You requested a review of the Master Concept Plan for Estero Crossing for compliance with the Placemaking Elements of the Village's Comprehensive Plan. Per our discussion, I have finalized that review and plan, and am sending two copies of the Plan and a pdf of the plan and letter.

**PLACEMAKING DIAGRAM**

**PLACEMAKING : START WITH ONE GREAT PLACE**

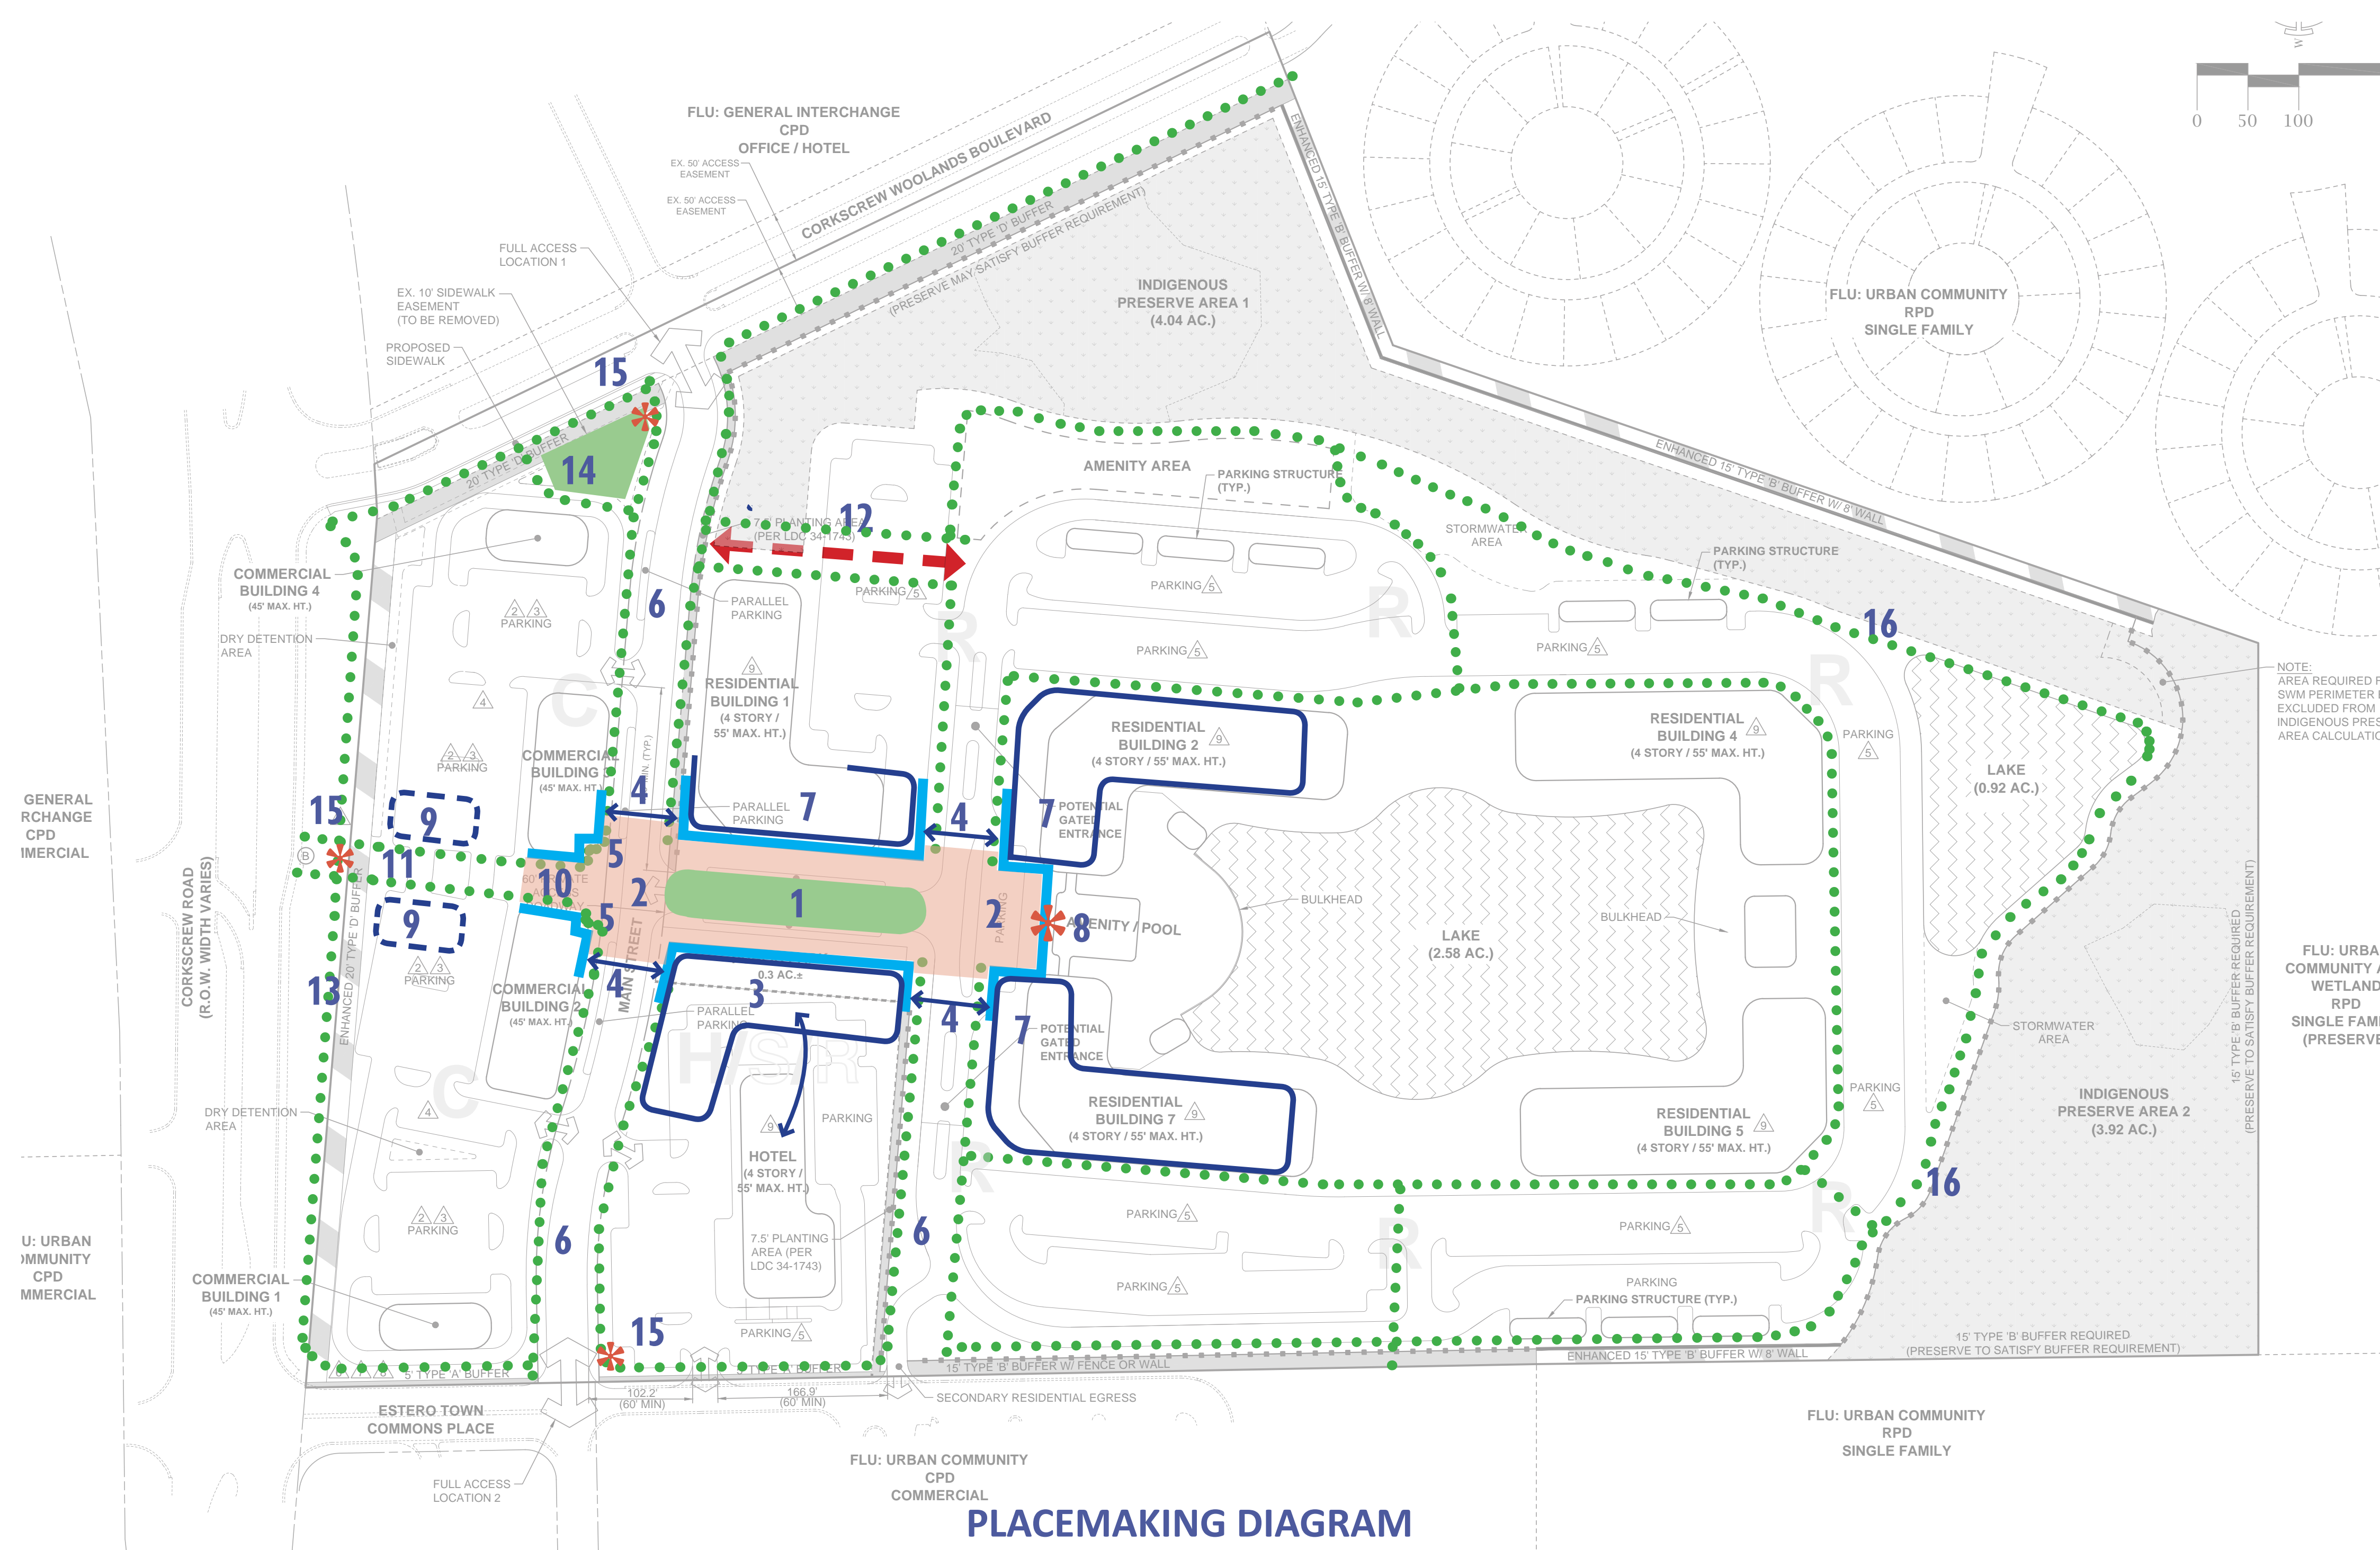
One comment may fall on the Village's side. The attached sidewalk along Corkscrew Road is not ideal along such a busy (and fast) thoroughfare. So, I proposed that a new sidewalk and/or a shared bike path be constructed that would be separated from the fast-moving traffic (ideally with a row of trees between). The other alternative would be to incorporate the sidewalk within the 20ft landscape buffer.

Using this approach, the reviewer recommends that the proposed buildings (commercial, residential, and hotel) be arranged to create **one great public space** that can function as a community gathering space. In this case a block-long urban green and plaza is proposed in place of the street that connects the Main Street to the residential amenity building. This is easily achieved by turning the proposed hotel approximately 90 degrees and aligning it with a proposed block-long street with a large center green-space that can be used for public functions. The public space must be defined by buildings that are situated close to the sidewalk (distance of 15-20 ft from the curb is generally recommended). The sidewalk should be wide with street trees and pedestrian-scaled lighting. The street around the perimeter can be one-way with parallel parking on the sidewalk side of the street.

Buildings along the perimeter of the public space should have "A-grade" facades (refer to diagram for extent) and active uses on the ground floor that may include commercial, residential, and hotel functions. A-grade facades refers to facades that are given special attention to detail, material, articulation, and with generous fenestration in the form of doors and windows (overly complex facades and roofs are not warranted). Multiple entries along the facade are encouraged. The facades at the ground level should have generous glazing in the form of windows and storefronts. Surface parking lots (other than street parking) should not be visible from the public space. Upper floors should have windows and, where desirable, balconies to foster interaction with the street.

**Internal drives** should be treated as part of the open space network and as **future streets**. The drives should have sidewalks, street trees and pedestrian-scaled lighting. This establishes the street and block network for future buildings.

**Proposed alternates to hotel:** The developer proposes two alternates to the proposed hotel: a storage building or a residential building. With either option, the urban form should match that of the hotel, that is, it should define the western edge of the proposed urban green-space. In the case of the storage building there should be some attempt to mitigate the negative impact of this "passive use" on the urban space. Therefore, it is recommended that active commercial uses (office, retail, etc.) be placed at the sidewalk level along the urban green with multiple entries along the sidewalk. The depth of the commercial uses can be shallow, but should not be less than 15ft. The upper floors of the storage building should have windows with a spacing similar to the residential buildings along the A-grade facades.

1. An **urban green** (20-40ft) is proposed. The green-space should be simply designed as a flat plane, with grass, pavers, and trees along the border. The space may be used as a quiet passive space, or be programmed at certain times to accommodate markets, music, etc.

2. **Traffic calming** achieved by using an alternative paving material for the public space to signify its importance and signal cars to slow down. The sidewalk can be raised or flush with the street and separated by planters and bollards.

3. Reposition Hotel/Residential/Storage building parallel to the proposed public space. At least one entry that connects to the building lobby should orient toward the public space.

4. Neck down the distance from building-to-building at the entrances to the public space to provide a greater sense of enclosure in the public space.
5. Wrap storefronts around corner of the commercial buildings to orient activity toward the public space. This is an ideal location for restaurants and cafes. The buildings can be notched to accommodate outdoor cafe seating.

6. Treat internal drives as future streets with street trees and sidewalks (min. 5ft).
7. Reposition residential buildings to define the street and create the urban open space.

8. Design the amenity building as an **identifiable landmark** of the plaza, give it vertical emphasis and "civic importance."
9. Recommended location of future commercial buildings to provide a gateway to the pedestrian zone. Alternatively, these could be open air structures, kiosks and other "lean" elements to help define the pedestrian connection.

10. Paseo- pedestrian connection between commercial frontage and urban greenspace.
11. Extend pedestrian paseo to Corkscrew Road. This would be an optimal location for a transit stop.

12. Consider an additional vehicular connection here. This would facilitate the closing of the urban greenspace for events like farmers markets, and concerts.

13. A detached sidewalk is recommended in place of, or in addition to, the existing sidewalk which is attached to the curb. This could be incorporated within, or adjacent to, the 20ft landscape buffer.

14. Proposed urban green with sidewalks on all edges. Could be used for outdoor seating.
15. Signage element that doubles as gateway element.
16. Proposed trail around the edge of the preserve. Ideally, this would be connected to trails on adjacent properties.
